# RESIDENTIAL BUILDING CONSISTENCY

February 7, 2018

## RESIDENTIAL CONSISTENCY

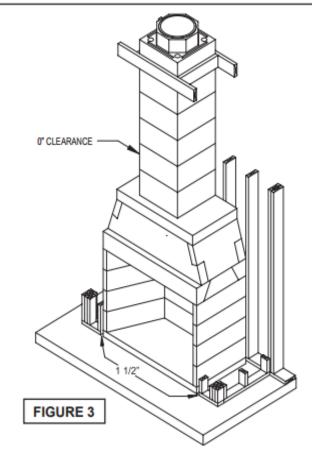
Q: Which trade looks at Isokern Fireplaces and the loads they add to the building?

Q: What are the required clearances for foam insulation?

## **Note**: Isokern has a 1 ½" Clearance to combustibles. There is also a 3" clearance to any insulation material having an R-Value.

A: Per conversation with Tommy Rowland, if there is no gas line involved, it falls to the Building Inspector. Must have engineering to cover the loads on wood floors. Follow Mfr's installation instructions for flue & fireblocking.

A: Depends on the foam & the fireplace

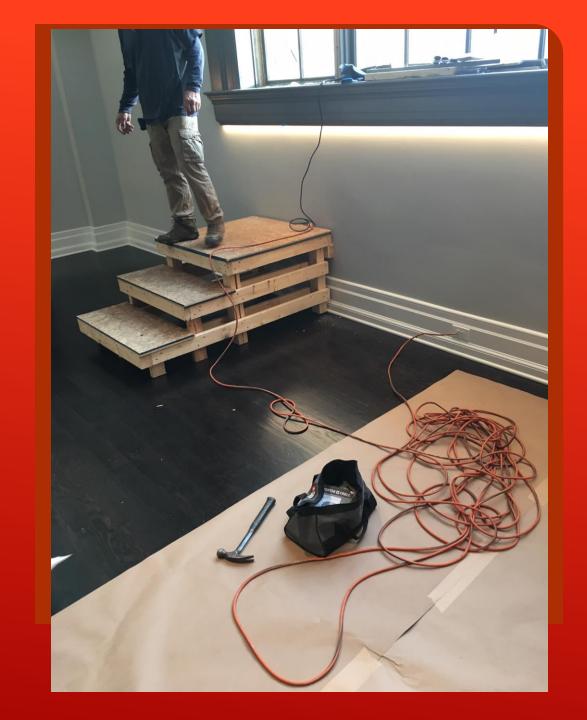
<u>Problem</u>: sill heights for windows are greater than 44".

<u>Solution</u>: a "permanent" platform. NOT!

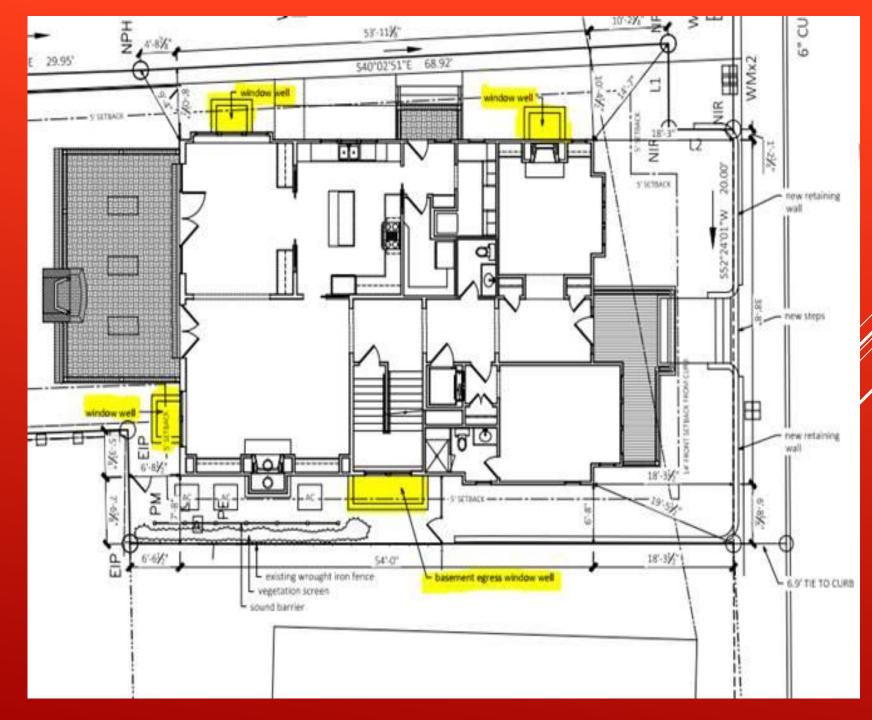
Problem: Four window wells varying in depth from 4' to 6' deep. At least one is for basement egress. Do they need guards around them for fall protection?

A: Not unless there is a walking surface within 3'. (similar to retaining wall requirements)

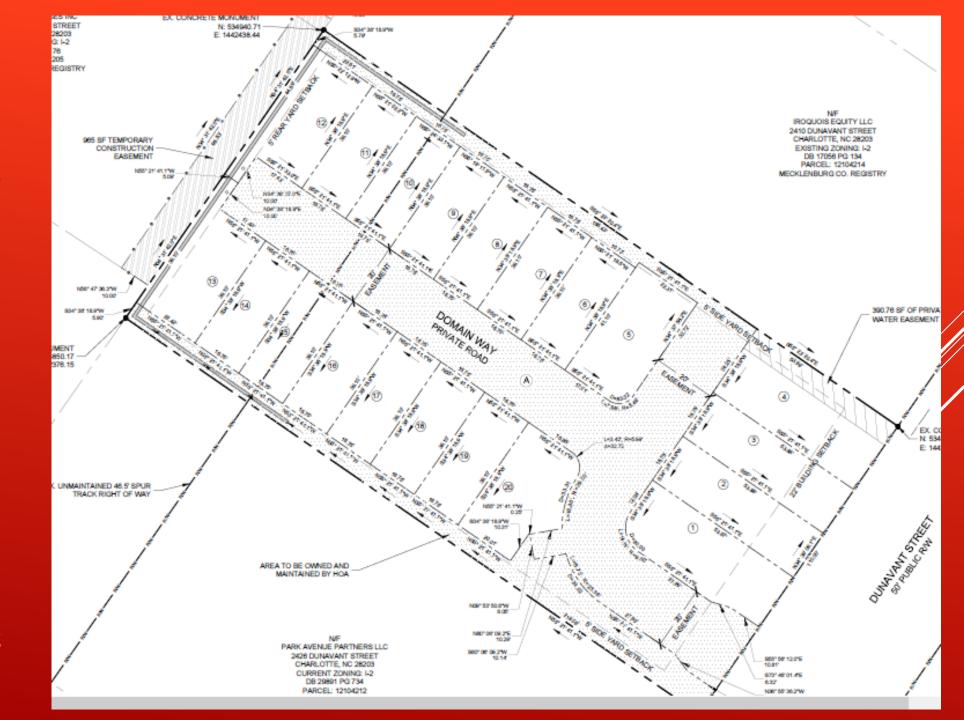
Problem: Emergency escape windows are on the back of the units which have fences and gates. Gates can be locked to prevent access to public way.

Solution: Common area at back of TH's was taken over by the HOA so it is left open at all times for access to public way.

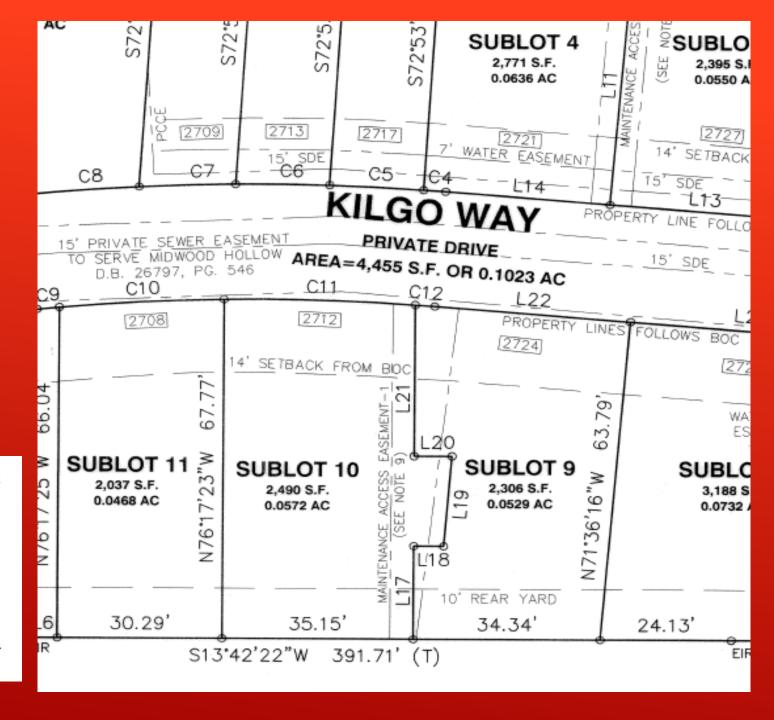
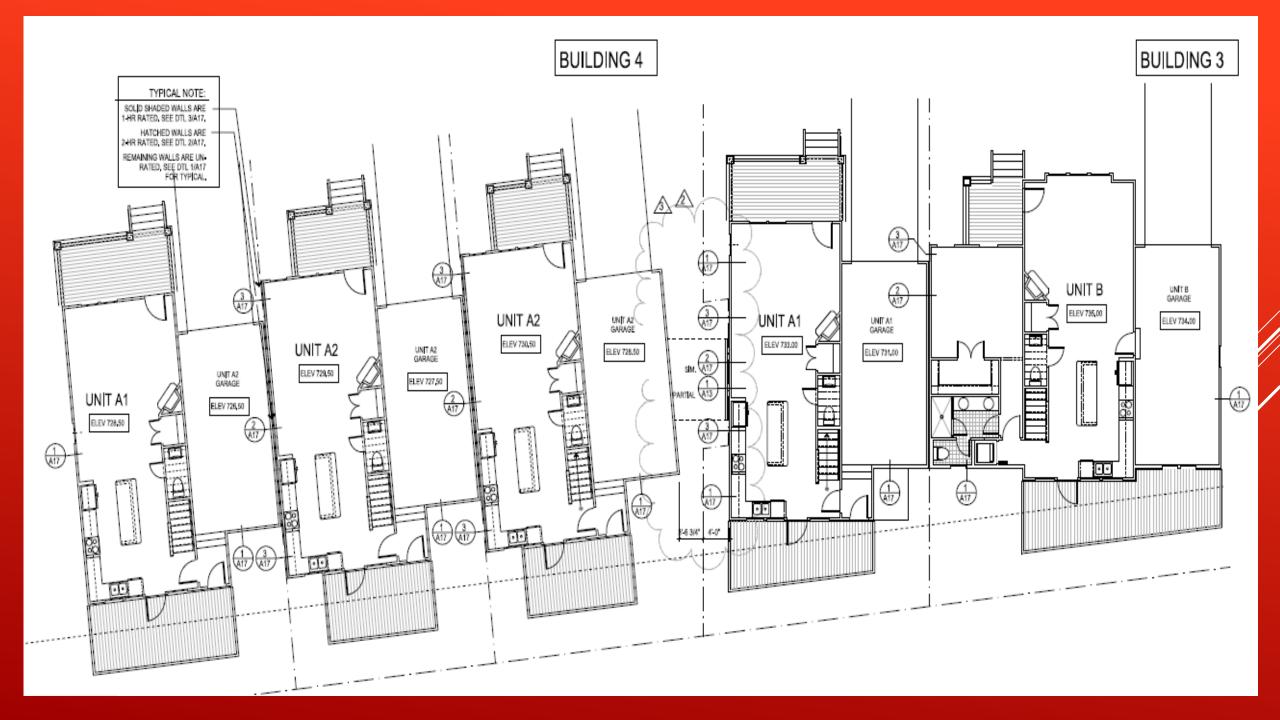
A maintenance easement was required for access to the back of the property. To accommodate this but not lose buildable space, the designer showed a 2<sup>nd</sup> story structure attached to one of the units. The pass-thru is for access but a property line and party wall divide the buildings

A: The definition from section R202 tells us where but if these are too close, an easement may be arranged between owners and the FSD measured to that easement. Note: the street, alley or public way must be publicly deeded property – not private.

## Q: What defines "immediate vicinity?"

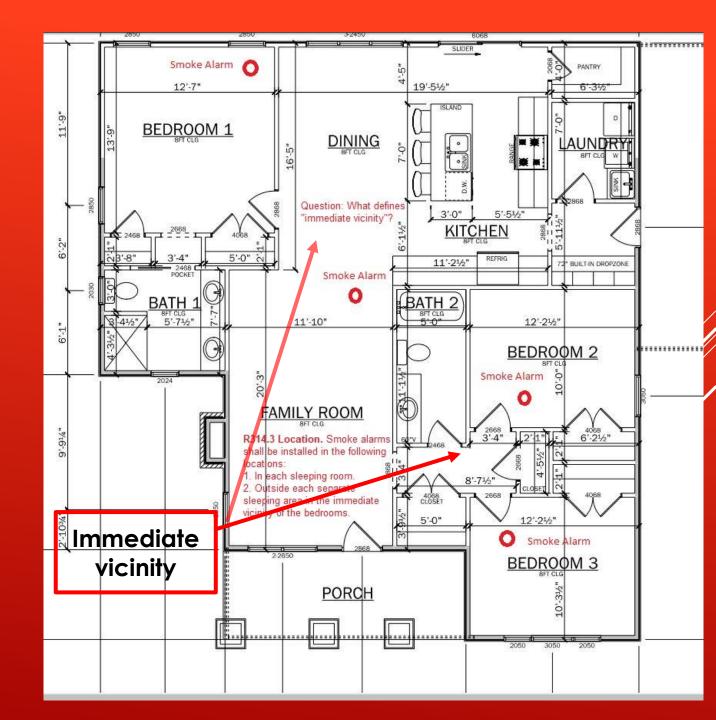
A: This drawing does not show the smoke detector within the immediate vicinity of any of the bedrooms. The idea is to identify the smoke hazard outside the bedroom doors so occupants have time to react.

## Q: What is a fourth floor versus an occupied roof?

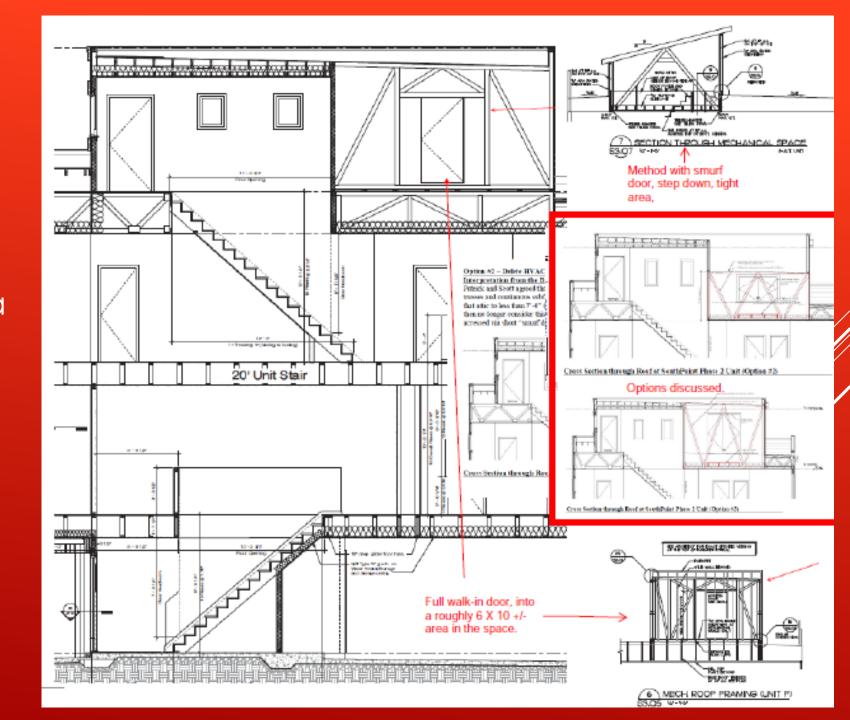
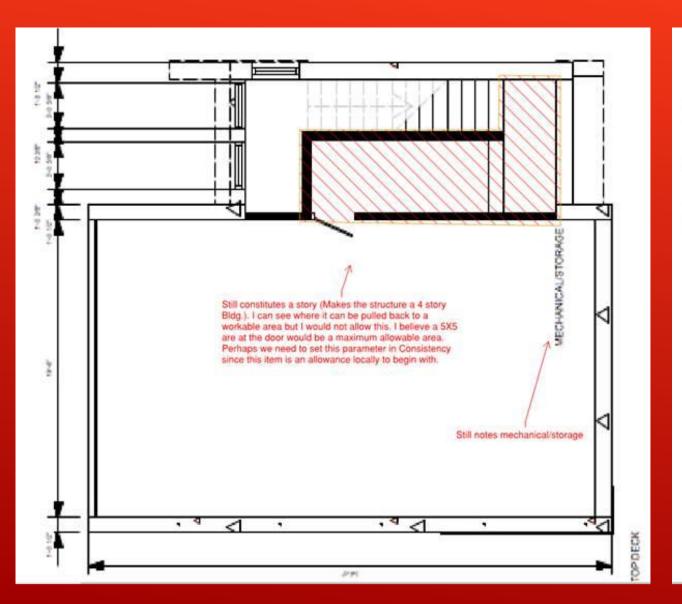
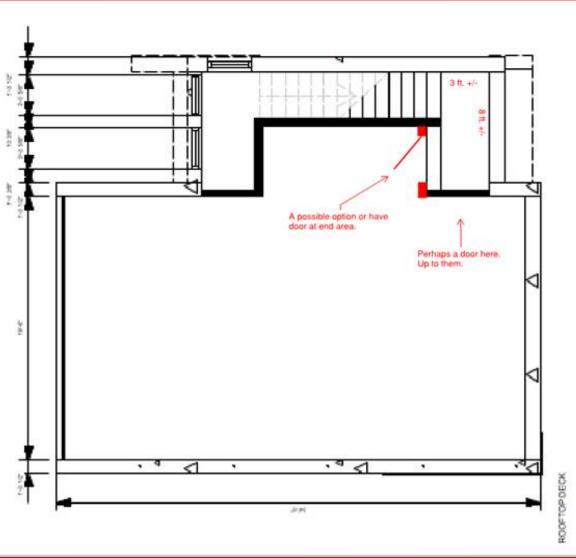
A: A story is defined by the measurement from a finished floor to ceiling joists or roof rafters above. The presence of both a floor and a roof constitutes a story.

On all future projects with roof top decks, in regards to stair tower access to those roof top decks, all stair tower landings will be limited to a maximum 25 sq. ft. of area in the stair. That would be a stair flight, to the landing at the access to the deck, maximum 25 sq. ft.

## Q: Is insulation required on TH foundation walls that are above grade?

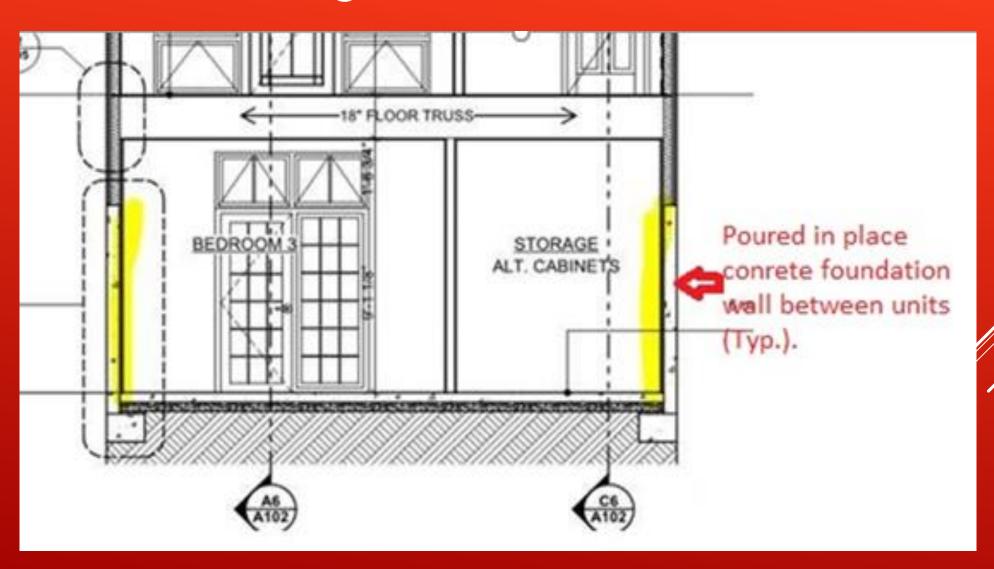
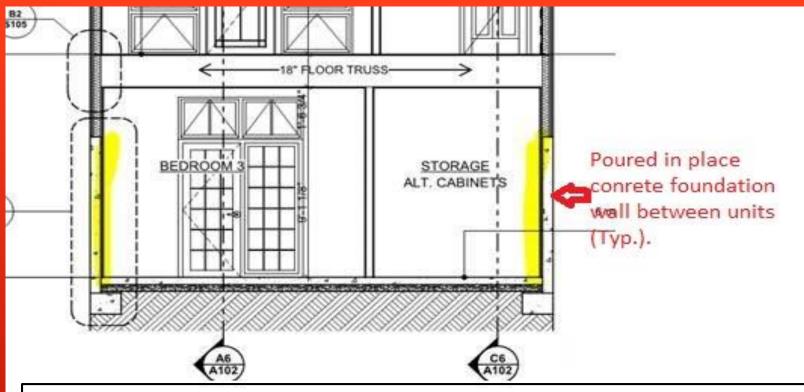
The interpretation is accurate; no insulation would be required for energy conservation code purposes in common walls separating townhomes designed for conditioned space on each side of the wall.

Be advised, the architect and builder have elected to apply R-11 insulation in the area separation walls and not insulate the lower masonry/concrete foundation walls between units, which can be allowed based on the NCDOI – OSFM - Eng. & Codes Div. interpretation, "Insulation Placement Between Multi-Family Dwelling Units", dated July 3, 2012. The interpretation states the thermal envelope of the building, in its entirety, is the thermal envelope. Therefore, units cannot receive a final inspection for building aspect until the entire thermal envelope is in place and inspections passed for all units within the building.
